STAFF RECOMMENDATION
3614 Richland Avenue
Lot 15, Richland Hall Development
November 15, 2017

Application: New construction—infill and outbuilding
District: Richland-West End Neighborhood Conservation Zoning Overlay
Council District: 24
Map and Parcel Number: 10409008800
Applicant: Chad Gore, Mike Ford Builders
Project Lead: Jenny Warren, jenny.warren@nashville.gov

Description of Project: Application is to construct a new single family infill and an outbuilding.

HOUSE SIDE ELEVATION (FRONT)

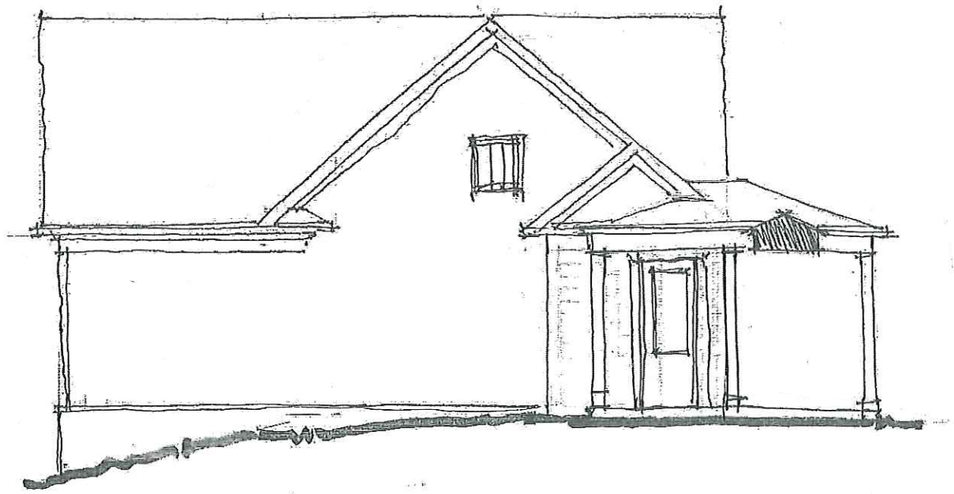
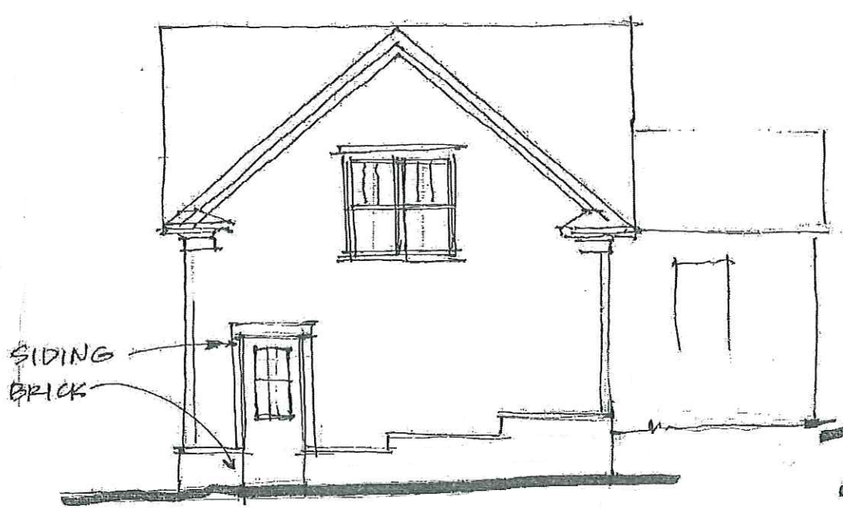
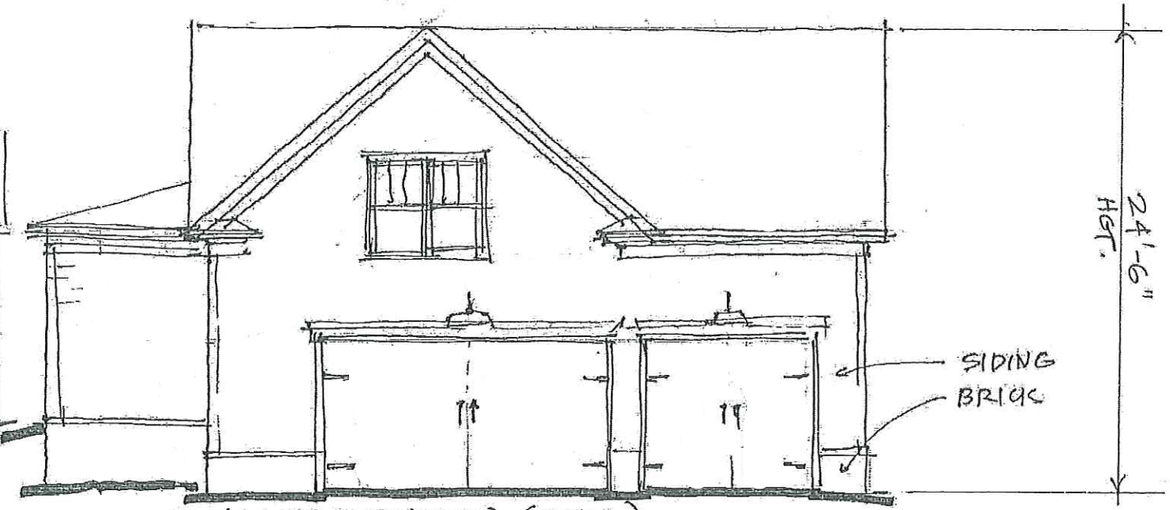
Infill	**Potential maximums (heights to be measured from grade)**	**Proposed (should be the same or less than the lesser number to the left)**
Ridge Height	35'	25'	24'6"
Eave Height	20'	17'	13'

Proposed Element	Proposed Form	Typical of district?
Primary form	Cross gable	Yes
Primary roof slope	11/12	Yes

Proposed	Color/Texture	Approved Previously or Typical of Neighborhood	Requires final Review
Foundation	Brick	Unknown	Yes	Yes
Cladding	Lap siding	Unknown	Yes	Yes
Roofing	Not indicated	Unknown	Unknown	Yes
Trim	Not indicated	Unknown	Unknown	Yes
Driveway	Not indicated	N/A	Yes	Yes
Windows	Not indicated	Unknown	Unknown	Yes
Pedestrian Door	Not indicated	Unknown	Unknown	Yes
Vehicular Door	Not indicated	Unknown	Unknown	Yes

9. Staff approve the materials for the outbuilding.
